TOWNSHIP OF ABINGTON

ADMINISTRATIVE CODE AND LAND USE COMMITTEE

A G E N D A **October 3, 2018** **7:00 P.M.**

Subdivision Application SD-18-03, 2219 Old Welsh Road and Parkview Avenue, Willow Grove, PA 19090 - Osman Aydemir

PLAN NO. **M-30-125-2**
 SHEET 1 OF 1

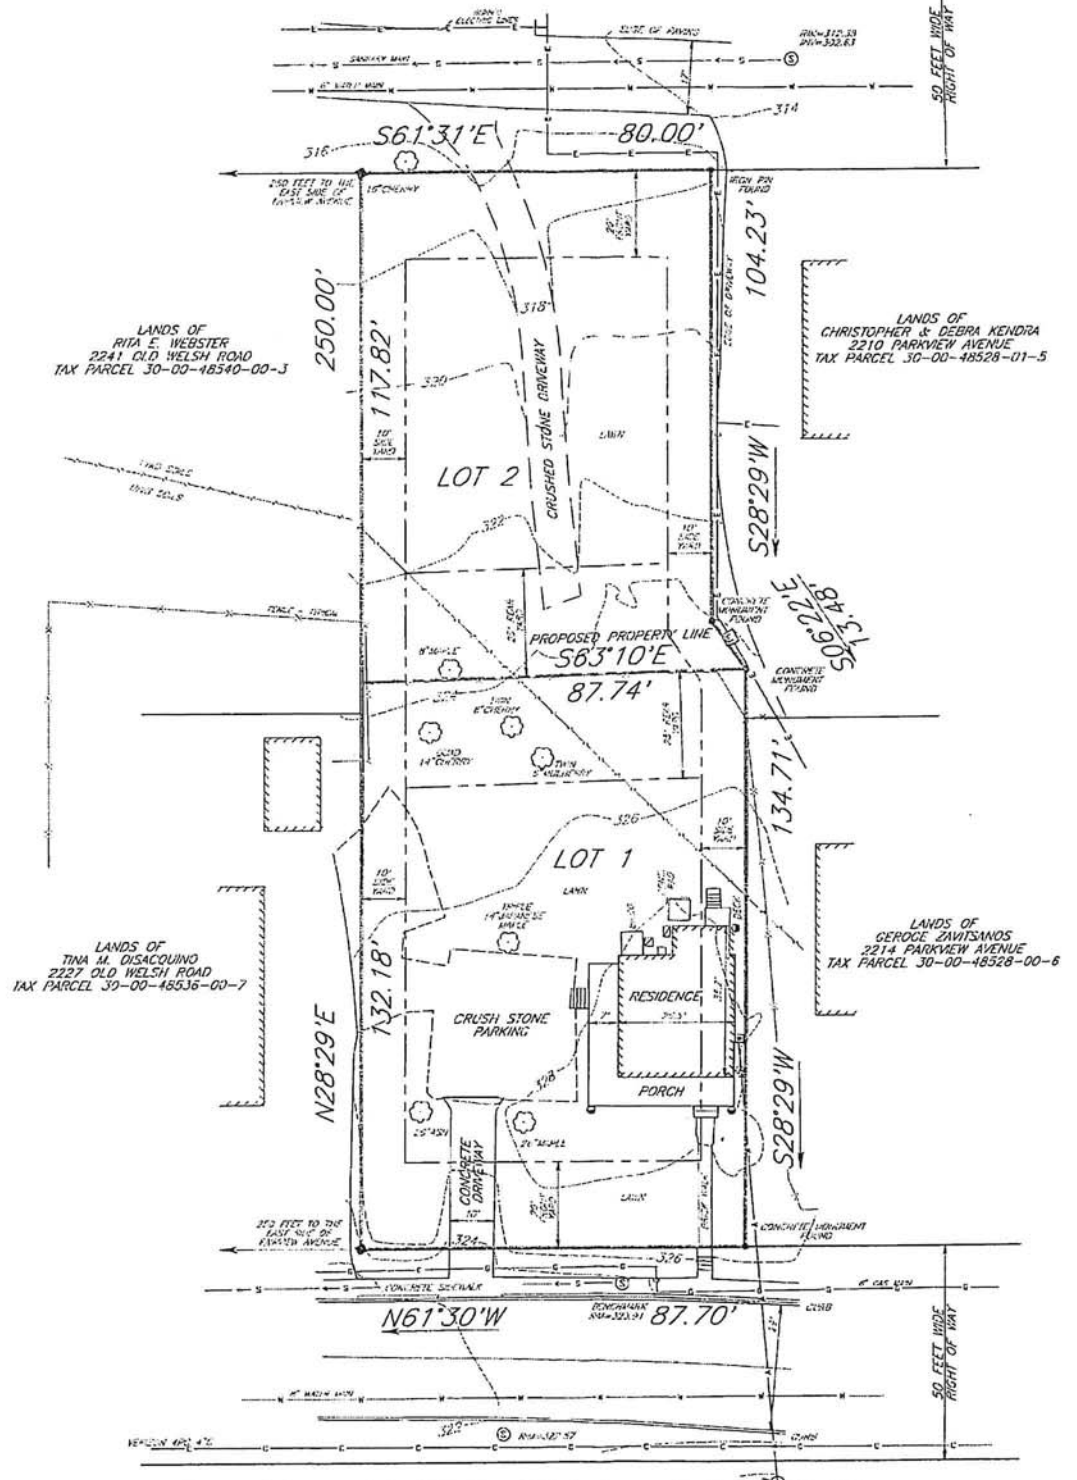
4. The existing crushed stone driveway on Lot #2 should be marked "To be Removed".
5. A sanitary sewer connection is required to be obtained for Lot #2. If this plan is approved, the Township of Abington is unable to sign the final plan until DEP approval is obtained for the required sanitary sewer connection. Please have your project engineer contact George Wrigley at 215-886-0934 with any questions pertaining to the required EDU.

6. The proposed dwelling is not plotted on the plan submitted for review. Please be aware that the Zoning Ordinance of the Township of Abington has requirements for in-fill development that applies to this project. Please refer to Section 2103.H, Use H-7 of the Zoning Ordinance.

1. The proposed lot will front Parkview Avenue. Sanitary sewers are available in this street and flow to the Abington Township Treatment Plant. Any questions or concerns regarding the sanitary sewers should be directed to Mr. George Wrigley, Director of the Wastewater Utilities.
2. Upon approval of this plan, the applicant shall provide the Township with two (2) new executed (signed, notarized and recorded) deeds; one for each property.
3. The plans should show a new concrete monument to be installed at the new property corner on the westerly side of the property. Iron Pins are not acceptable.

4. The plan must show ALL utility services (sewer laterals, water services, wells, septic tanks, seepage pits, overhead electric, underground cable, etc.) on each property so as no newly formed property cuts off a utility to the other property.
5. The plans should show a conceptual residential footprint, with a driveway and stormwater management system.
6. The side yard setbacks should be removed in the rear portion of both new lots.
7. Old Welsh Road is a State Road. Any improvements made within either the roadway or the legal R.O.W. will need the approval of PennDOT.
8. This review is for the subdivision process only. Before any construction begins, the owner/applicant must obtain the proper permits from the Township offices.
9. When the Subdivision is approved, the address for "Lot 2" will be 2218 Parkview Avenue.

PRELIMINARY/FINAL SUBDIVISION
 SHEET NUMBER: **C1.01**
 1 OF 1

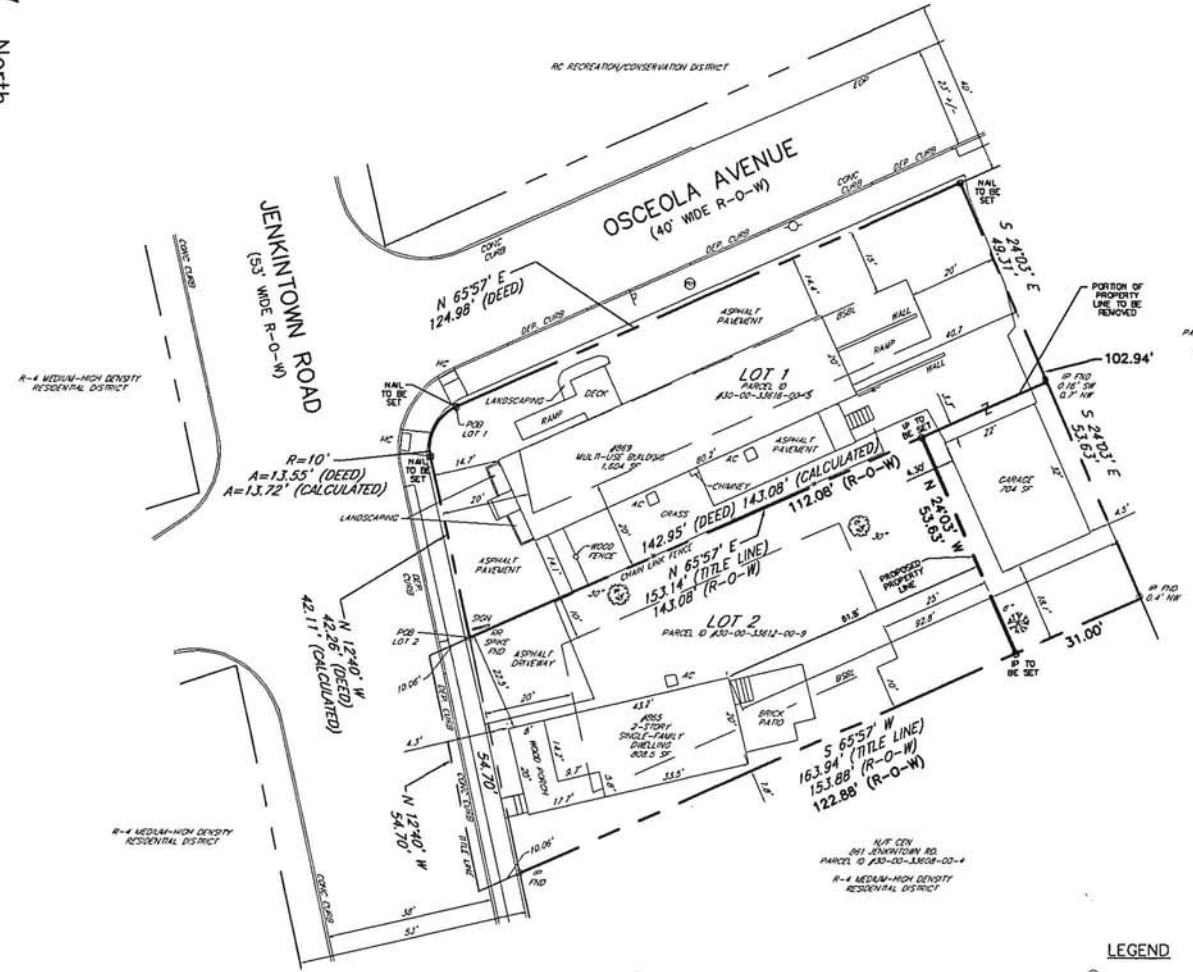
6. The proposed iron pins marked on the plan as "To Be Set" must be replaced with concrete monuments. Abington Township does not permit iron pins. Please refer to Section 146-32 of the Subdivision & Land Development Ordinance of the Township of Abington.

Attachments: Annotated Plan
Reduced Copy of Applicant's Plan
Aerial Image

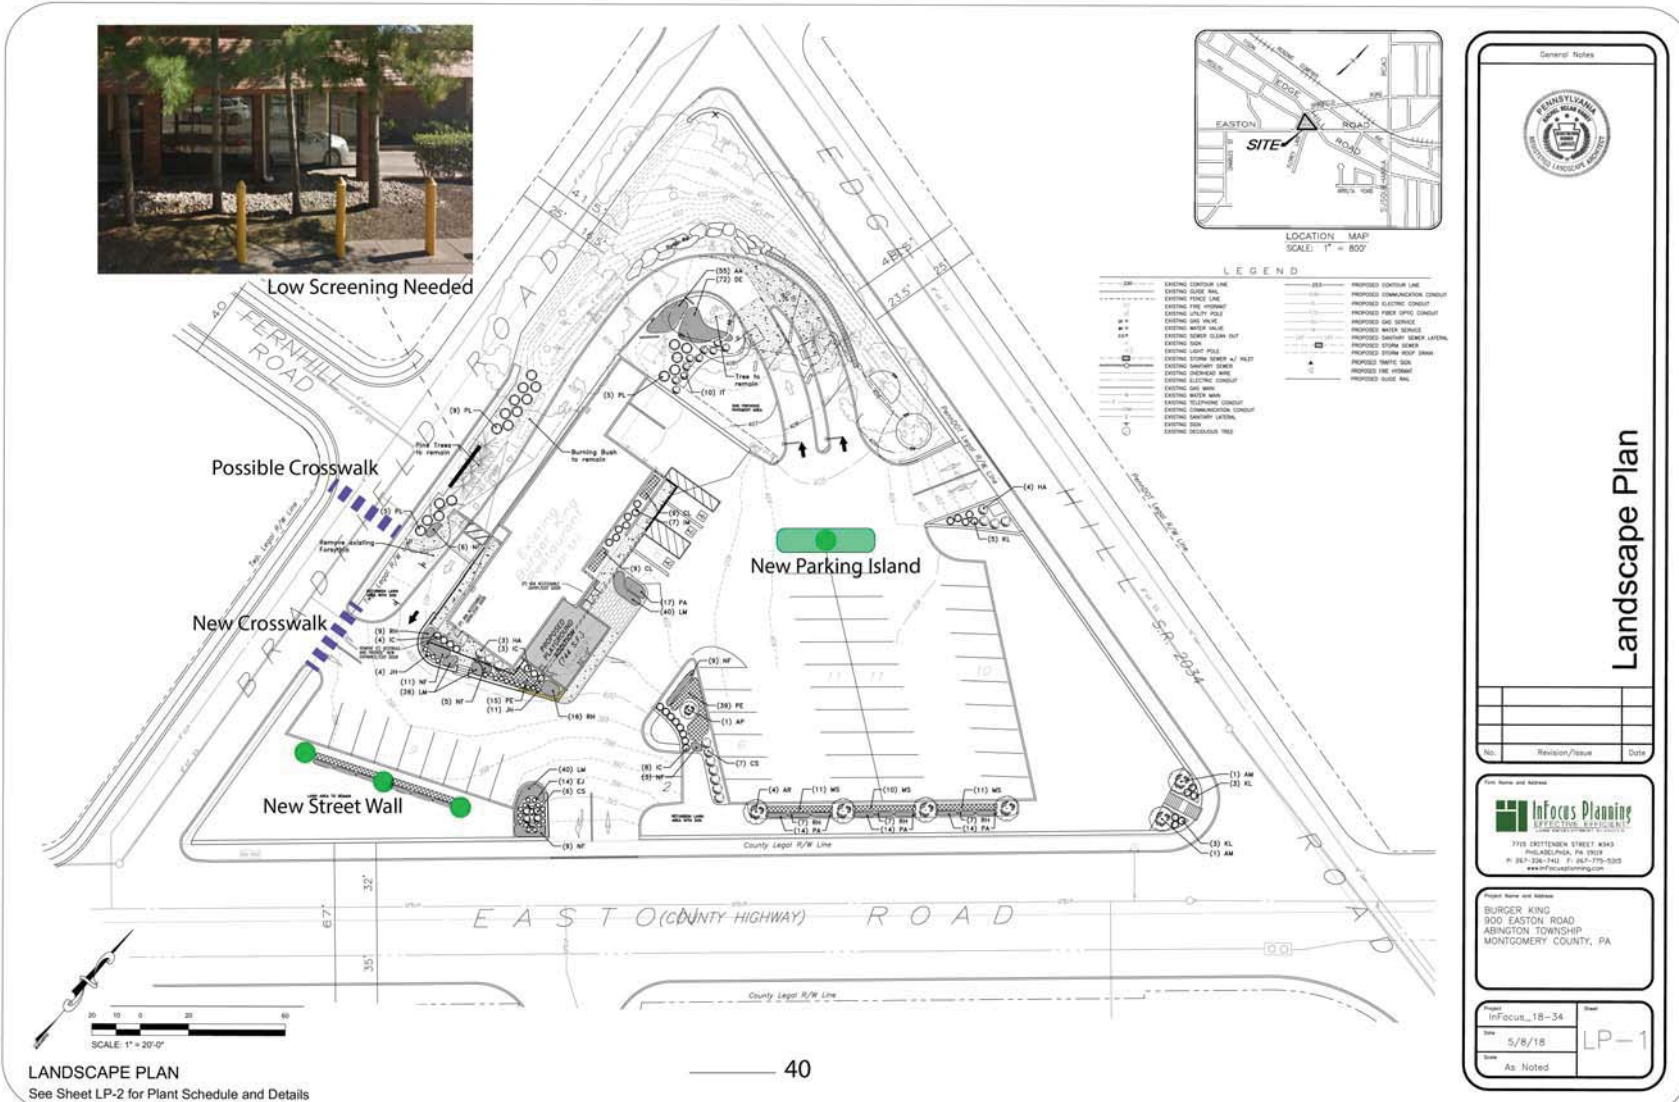
- B. Street Wall. Figure 10.19 requires a “street wall” [for specifications, see §2500: Street Wall] when a building is located more than 20 feet from the ultimate right-of-way. There is a wall on Easton Road, between the Easton Road vehicular access point to the Burger King and Bradfield Road, but it serves as more of a retaining wall, has no landscaping and does not screen cars and headlights parking in the nine closest spaces in the parking lot. Although the parking lot is approximately four feet higher than Easton Road, headlights from cars parked in this area may be a nuisance to motorists, pedestrians and residents of the apartments across Easton Road (many of the trees adjacent to the apartments are deciduous, and thus only provide screening benefitting apartment residents part of the year). Since a street wall is required, we recommend one be constructed in front of the nine parking spaces [SEE ANNOTATED PLAN]. If the existing retaining wall is credited to the applicant as a street wall, we recommend the required landscaping portion be planted so as to screen the headlights of cars parking in the nine space row.

- A. Separator Island. Figure 10.19 refers to an island required to separate inbound from outbound traffic at vehicular access points [this can be low to the ground, so it may be driven over by delivery trucks and emergency vehicles].
